SERVICE BULLETIN

Classification: AN21-010	Reference: NTB21-054	Date: June 22, 2021
-----------------------------	-------------------------	------------------------

2020 TITAN/TITAN XD; REAR VIEW MONITOR OR NAVI SYSTEM ISSUES

APPLIED VEHICLES: 2020 Titan/Titan XD (A61)

Figure 1

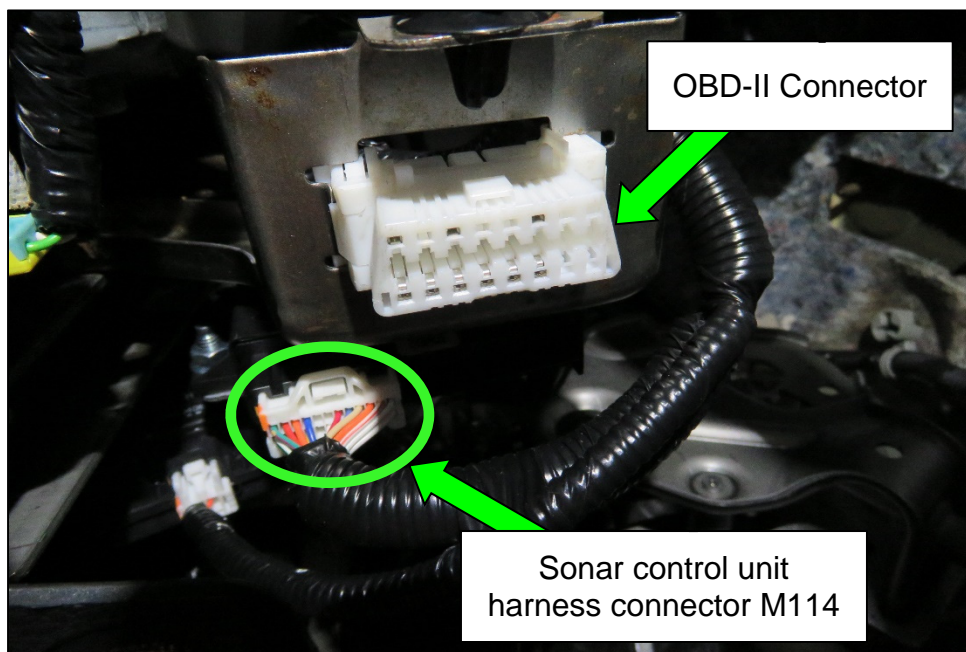
1. Locate the white 24 pin sonar control unit harness connector M114 near the OBD-II connector (Figure 1 and Figure 2).

Figure 3

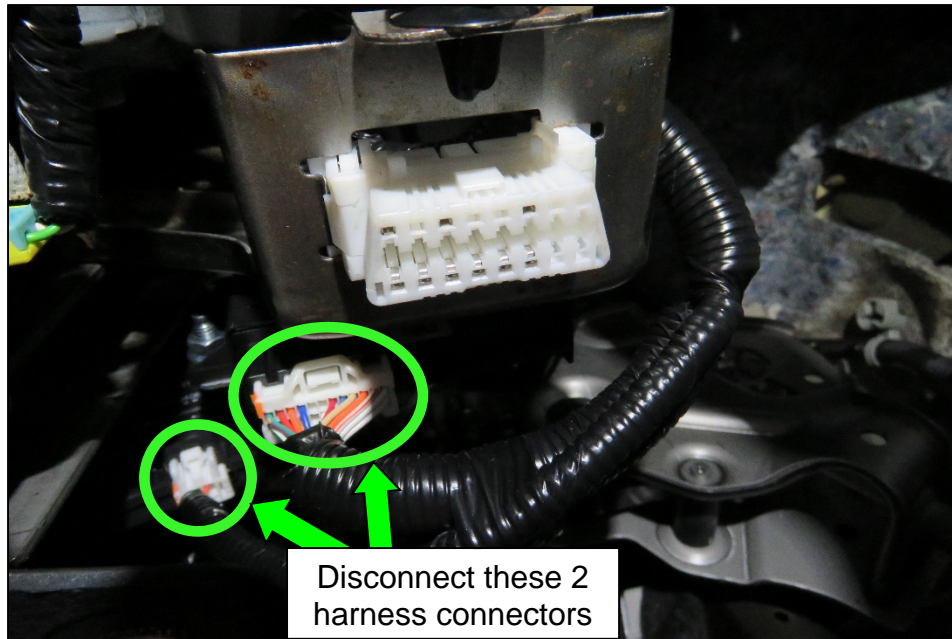
2. Disconnect the white 24 pin sonar control unit harness connector M114 and the smaller white harness connector near it (Figure 3).

Figure 4

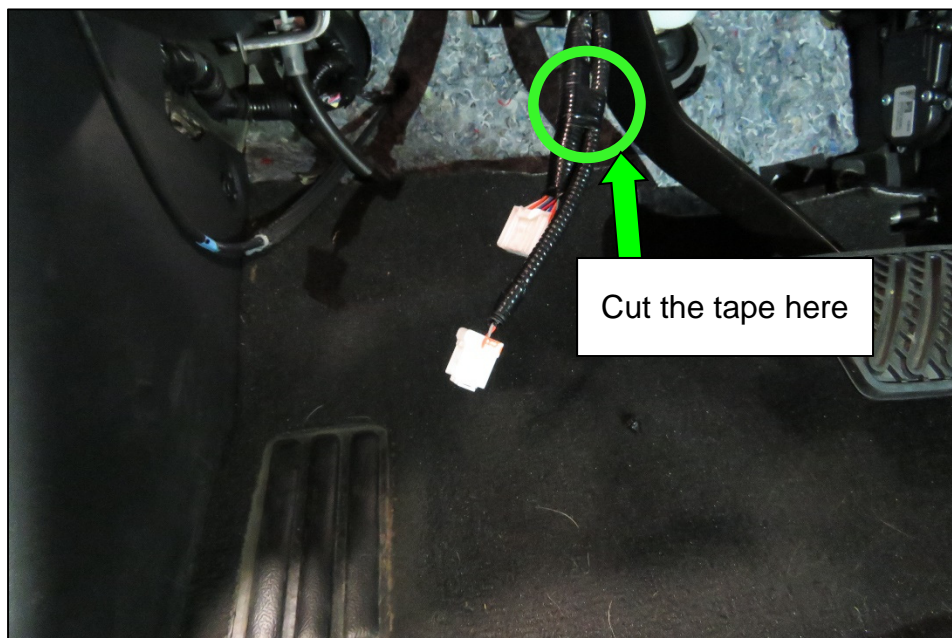
3. Allow the 2 harness branches to hang down, then carefully cut the tape to separate the 2 harness branches (Figure 4).

Figure 5

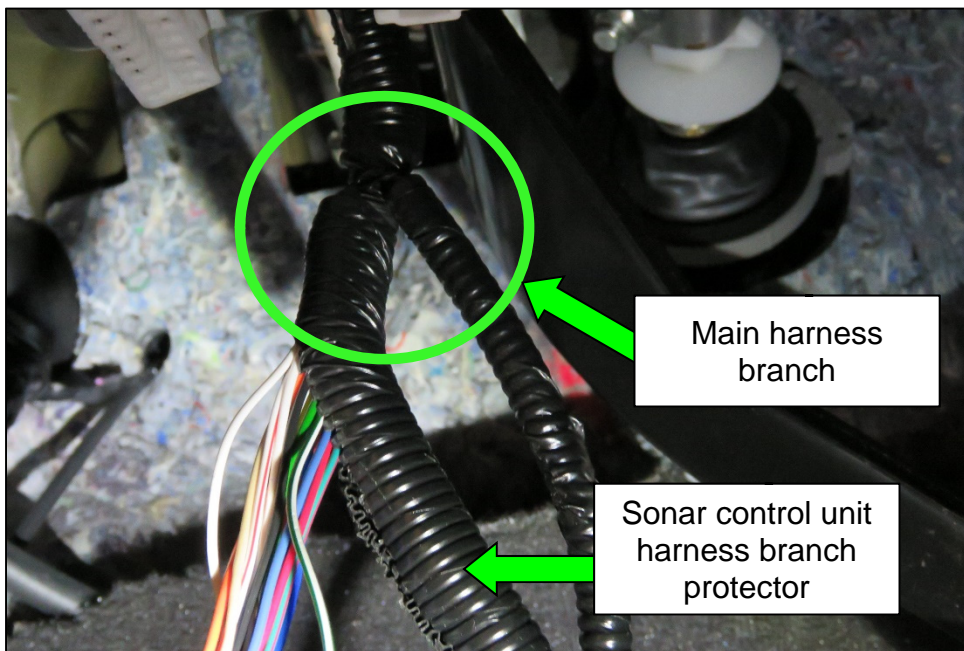
4. With the 2 harness branches separated, carefully remove the vinyl tape that bundles the sonar control unit harness together.
5. Carefully pull back approximately 100 mm (4 inches) of the outer sonar control unit harness branch protector (Figure 5).
 - Most if not all of the sonar control unit harness branch wiring should be exposed up to the main harness branch.
 - Ensure a minimum of 50 mm (2 inches) of wire is exposed.

Figure 6

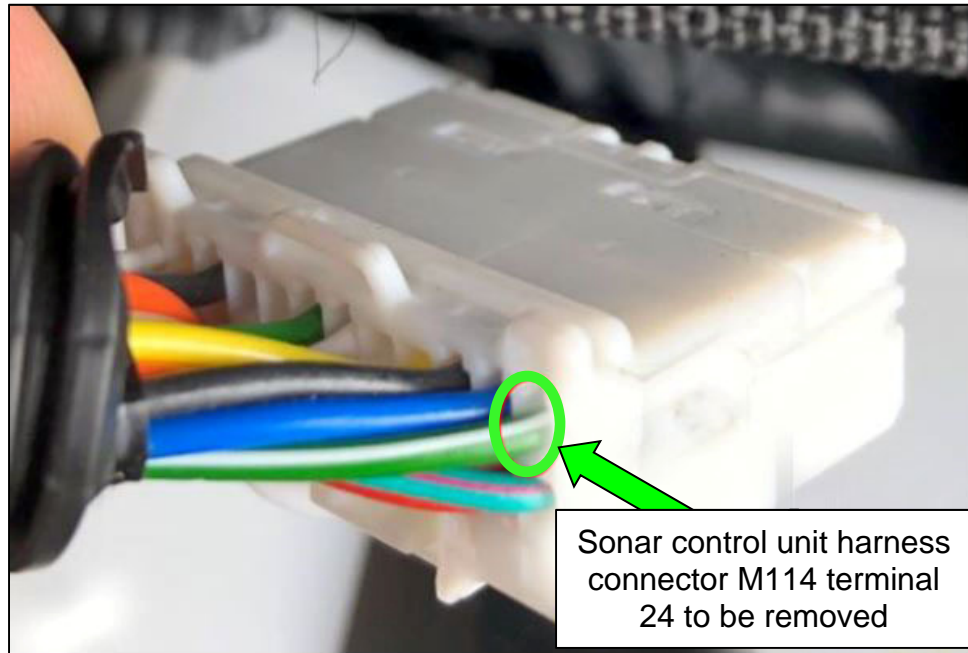
6. Identify the sonar control unit reverse position input wire (Figure 6).
 - The sonar control unit reverse position input wire is terminal number 24 and is green with a white stripe.

Figure 7

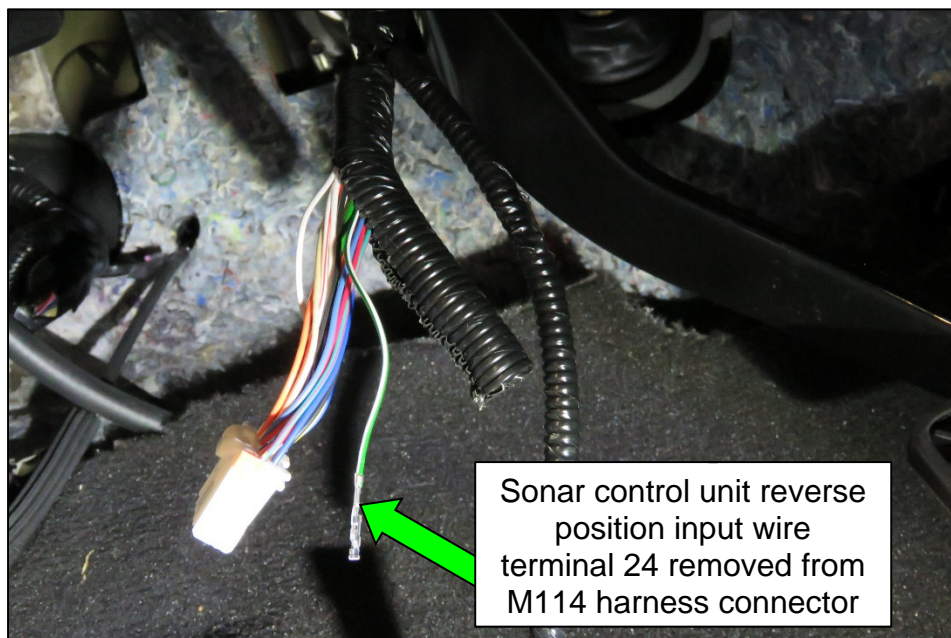
7. Follow the instructions in ASIST for the Harness Repair Kit User Guide to remove terminal 24 from the M114 harness connector (Figure 7).

Figure 8

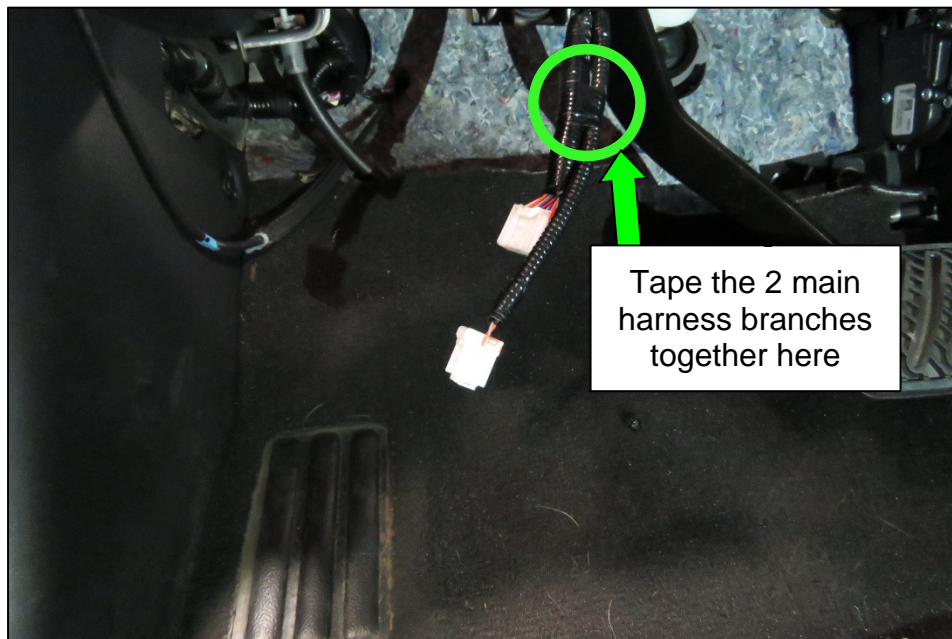
8. Cut the sonar control unit reverse position input wire approximately 50 mm (2 inches) from harness connector M114 and remove the 50 mm (2 inch) section of wire from the sonar control unit harness branch.
9. Completely cover the cut end of the wire with tape.
10. Completely cover the 100 mm (4 inch) section of the sonar control unit harness branch with tape.
11. Completely cover the 100 mm section of the sonar control unit harness branch with the outer protector, as it was originally.
12. Apply vinyl tape over the outer harness protector, similar to what was present originally.
13. Tape the 2 main harness branches back together like they were originally (Figure 8).

Figure 9

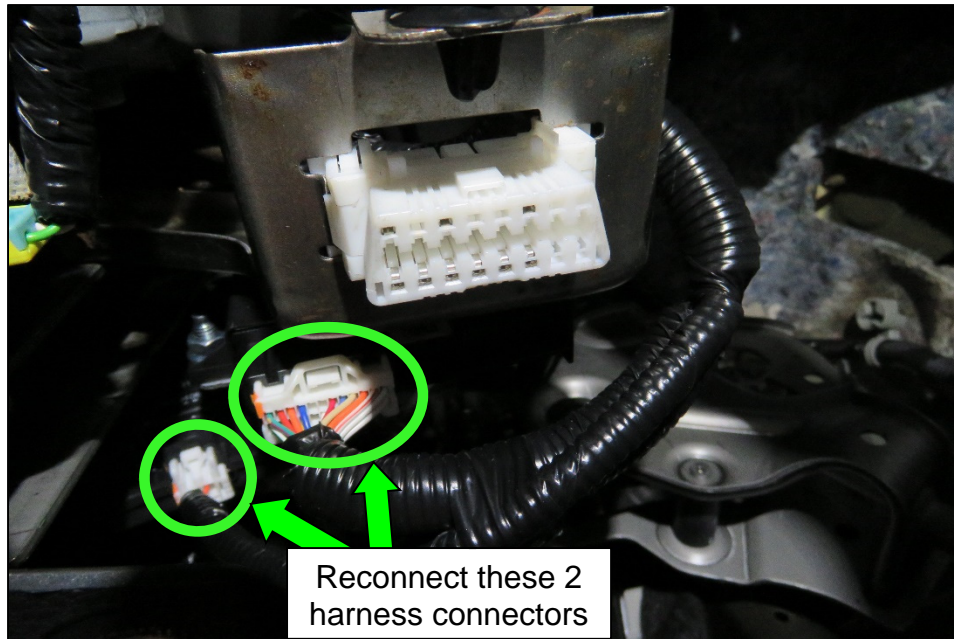
14. Reconnect the white 24 pin sonar control unit harness connector M114 and the smaller white harness connector near it (Figure 9).
